> Customer Product Information (CPI)

Product group:	SEMIPACK	Rev.:	0
No.:	PN20-101	Errata of SEMIPACK 4 datasheets	27 Oct 2020

Subject of change: Datasheet correction

SEMIKRON SEMIPACK 4 modules
product type:

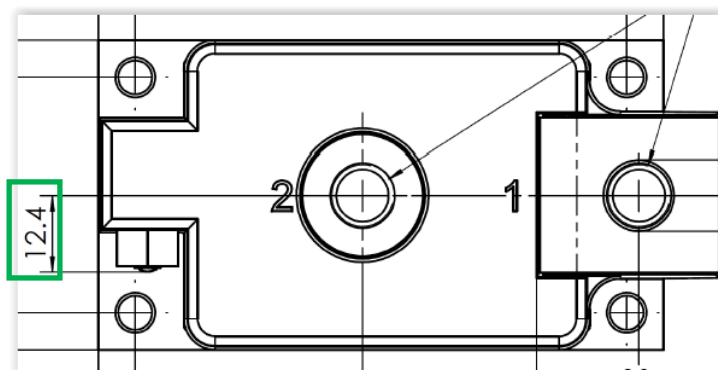
Description of change: Correction of the module weight in the datasheet. In the new revision the correct typical value of 840 g will be specified instead of the wrong value of 940 g.

Additionally, for the thyristor types (SKET) the drawing will be adapted. The correct distance of the top of the auxiliary contact from the module length axis is 12.4 mm, while in the former drawing this distance was wrongly given as 11.5 mm.
